**Re: Saab Albuquerque Grading and Drainage Plan (C-18/D35)
Engineer's Stamp Dated March 13, 2003**

**Re: AMERICA'S PASSTIME, Grading and Drainage Plan
Engineer's Stamp Date 06/11/2012 (C18/D035)**

**AMERICA'S PASTTIME
GRADING & DRAINAGE PLAN**

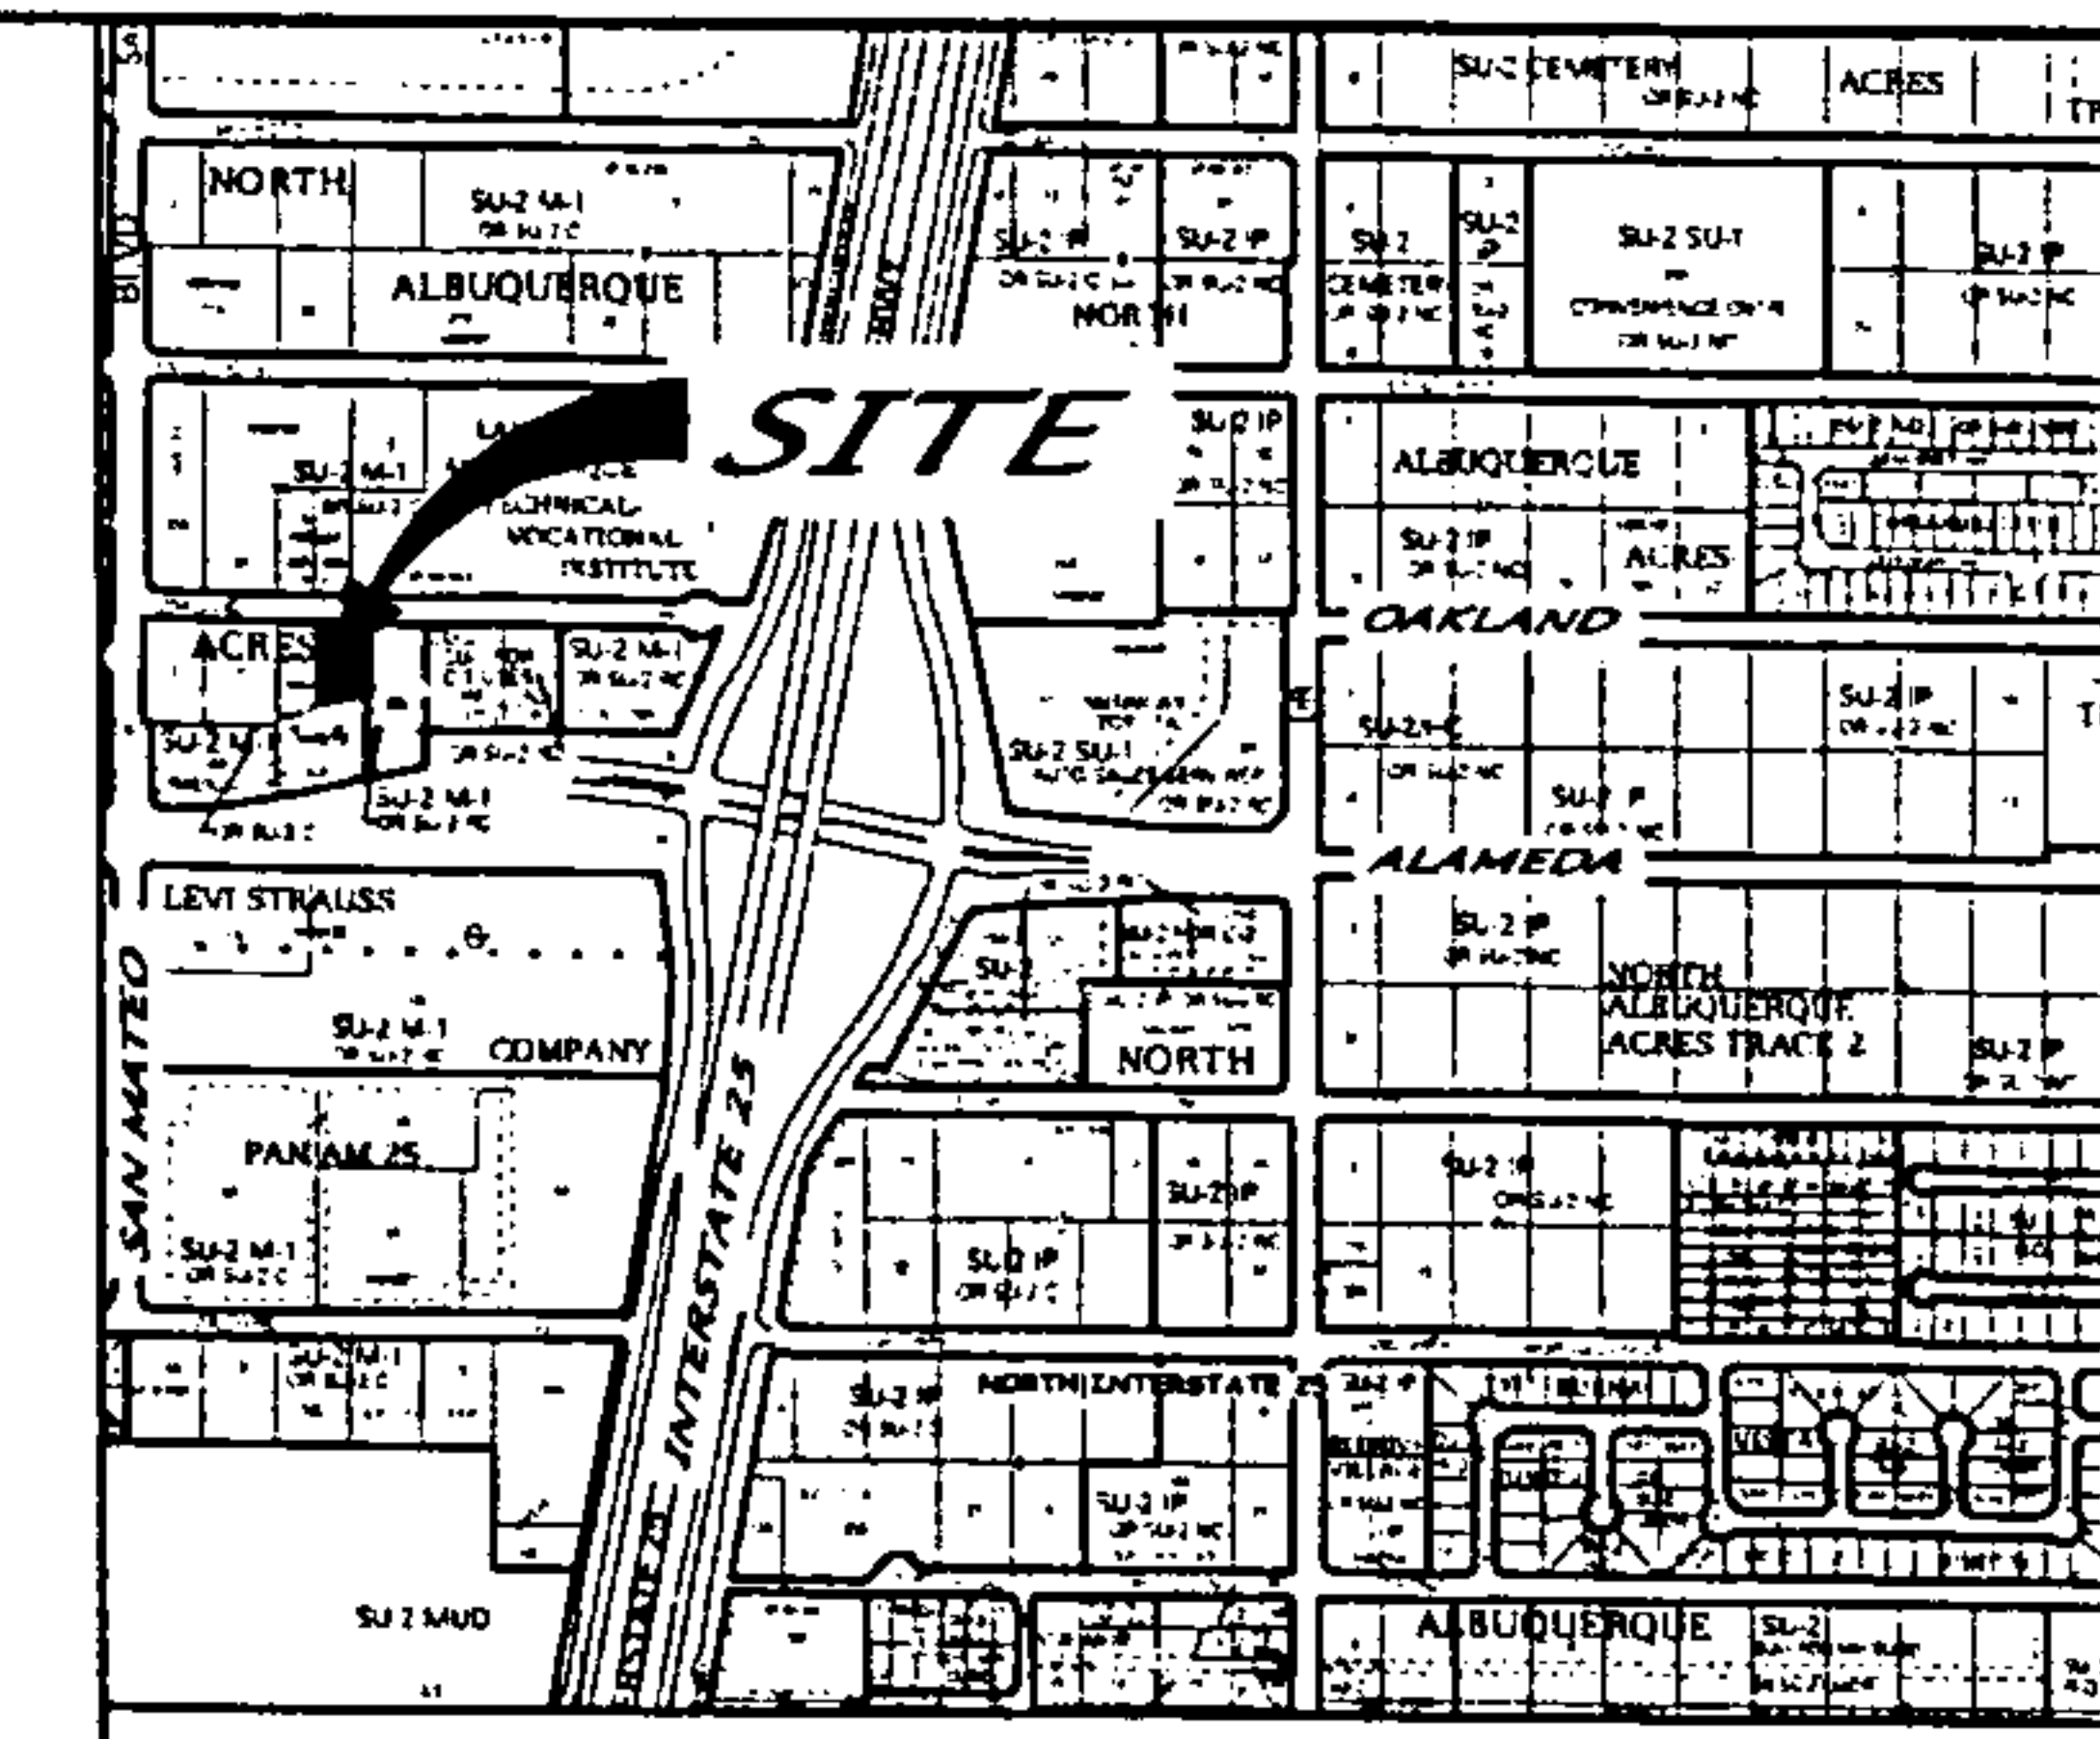
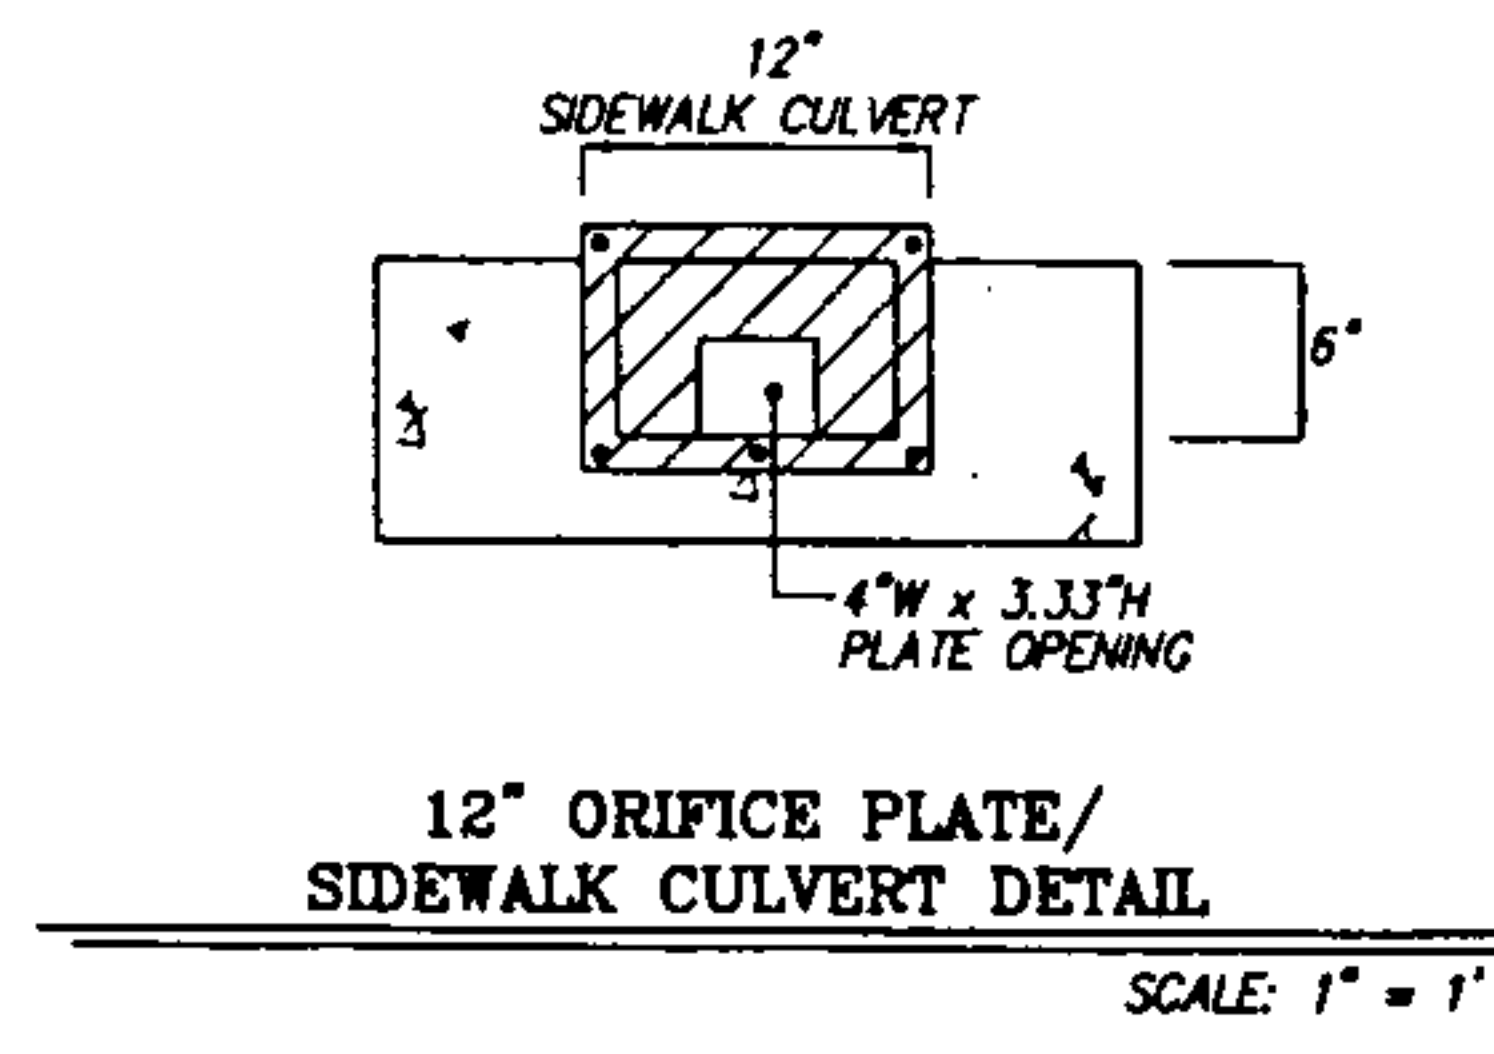
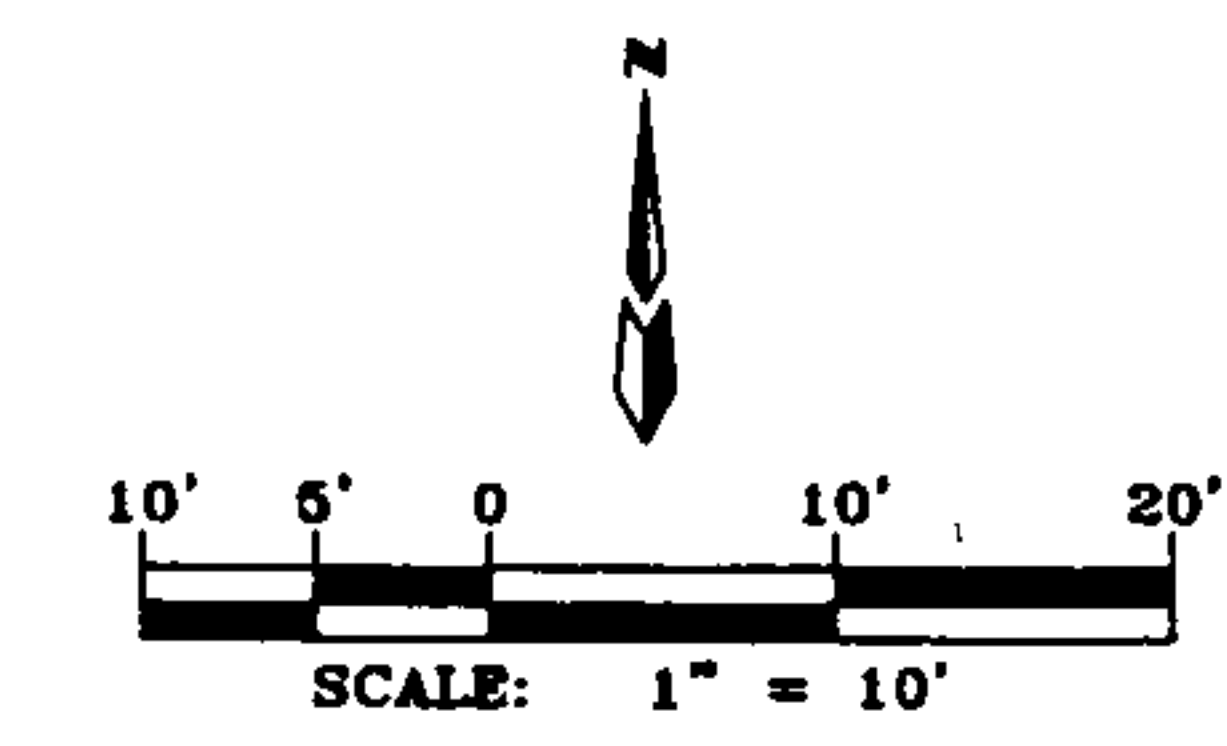
- Sidewalk culvert plate should be extended from the curb to 2' south of the property line. Call out the City of Albuquerque Standard drawing number 2236. Include a note that the contractor will tack weld the bolts on the plate.

- Include the size for the proposed curb opening at the northwest corner of the northerly parking spaces
- Portion of the proposed detention pond will an approximate 3' cuts into the exiting public utility easement. Can the pond be revised to stay outside the easement?

- Show the proposed Handicap Ramp on the plan.
- An invert of the 66.60 is call out on the plan on the northwest corner of the building. How does the runoff enter the pond from this location? Please provide details. Since the WSEL is at 66.70 please make sure that the runoff will not overflow into the adjacent property. The elevations at the property line may have to be at 67.00 or higher.

- Provide an emergency overflow and calculations for the pond.
- Please provide slope treatment and a typical section for the areas where the grades exceed 3:1 slope. Please check the grades along the easterly property line.

- Make a definite determination if retaining walls are required.
- Change note number 2 under the "Notice To Contractor" to update #8 .
- Hydrology is requesting that proposed landscape areas be depressed.

- Please revise “(See Note 2)” to “(See Note 1 & 3)” at the 12” sidewalk culvert.
- Is the 8” PVC (with an invert of 66.60) on the northwest corner of the building through a proposed wall? Please provide a detail.

Also, at the DRB last week a new pedestrian connection was shown on the site plan which is not shown on the revised grading plan. Since the entrance grades are over 8% we will need to see the grades along the path to assure handicap accessibility is met.

- Please revise the 12" Orifice Plate detail to show the full wall height at 67.83 & 97.3 with the emergency overflow. Call out the invert of the opening.
- Provide the AHYMO routing calculations for the proposed pond.
- Please revise "(See Note 2)" to "(See Note 1 & 3)" at the 12" sidewalk culvert.
- Is the 8" PVC (with an invert of 66.60) on the northwest corner of the building through a proposed wall? Please provide a detail.

I added a Note 4 to detail the construction of this item.

The handicap parking space into the building is ADA accessible. The sidewalk from Oakland to the building is for pedestrian access only. If you have questions with regards to the ADA component, please call Rick Bennett, the Architect for this project at 242-1859.

1. Sidewalk culvert extended 2' and City standard 2236 added as well as tack weld note.
2. 12" wide curb opening size noted on plan.
3. Pond removed from 10' PUE.
4. Handicap ramp detail added to plan.
5. Runoff from side swale enters through an 8" PVC pipe.
6. Emergency overflow and calculations have been added to the plan.
7. Note added for slope treatment on slopes greater than 3:1.
8. Retaining wall notations added.
9. Revised to Update #8.
10. Not sure where landscape areas may be depressed. Landscape areas around the perimeter have swales, but grades are dictated by needing to match back to existing offsite grades.

1. Full wall detail shown on plan with invert call out.
2. AHYMO printouts provided.
3. Note has been revised.
4. Note 4 has been added for construction of 8" PVD pipe penetration through wall. The invert is at 65.00 as shown on the plan.
